**S-TYPE**

S303-S159

SERVICE**TECHNICAL BULLETIN**

Engine In Limp Home/Check Engine MIL –
Water Ingress into Throttle Position Sensor –
Service Action S159

ILLUSTRATION 1

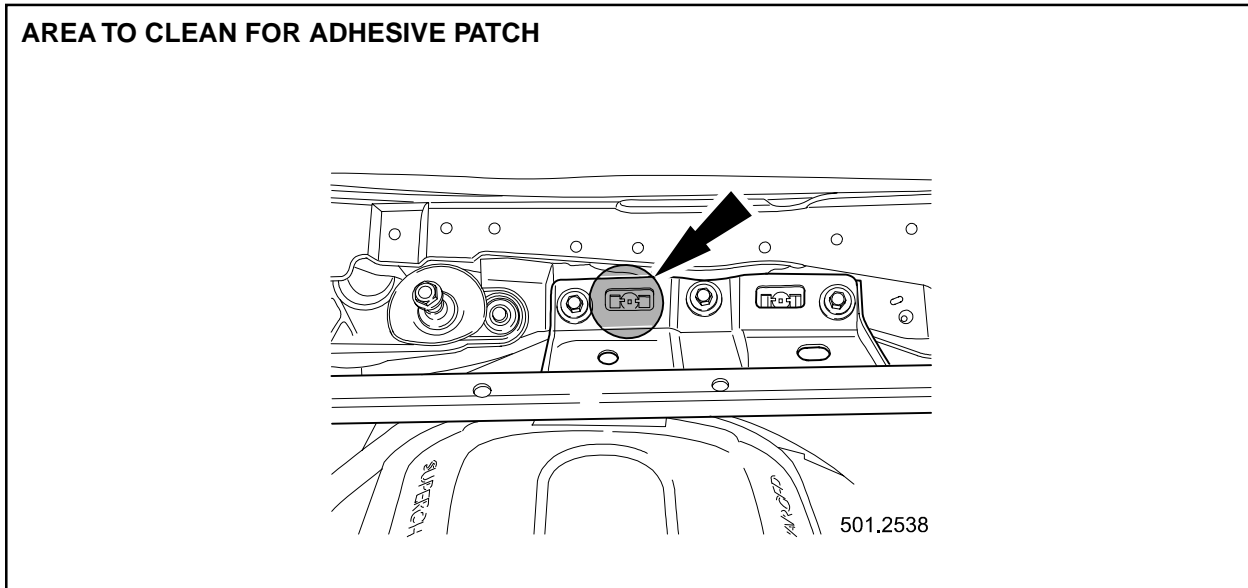
A concern has been identified on 2003-04 MY S-TYPE R vehicles within the above VIN range. It is possible that during washing of the vehicle, by car wash or jet wash, the water can run through the cowl panel grille-fixing hole into the throttle position sensor housing. This can result in the throttle position sensor failing to function, the engine management system defaults to 'limp home' mode, and a warning MIL is displayed.

A sealing patch is available to prevent water flowing directly from the cowl panel grille onto the throttle position sensor.

On 2003-04 MY S-TYPE R vehicles within the above VIN range, install a sealing patch on the mounting hole located on the suspension turret cross brace at the bracket securing it to the bulkhead.

- Clean the area indicated on the bracket of the suspension turret cross brace where it secures to the bulkhead (Illustration 1).

- Ensure the plastic insert is central in the rectangular hole of the brace.
- Remove and discard the backing from the adhesive patch and install the patch centrally over the right hand rearmost rectangular hole (Illustration 1) of the suspension turret cross brace.
- Reinstall the cowl panel grille, see Workshop Manual, JTIS CD ROM, section: 501-02, SRO 76.10.01.
- Remove fender protection kit and close hood and door.
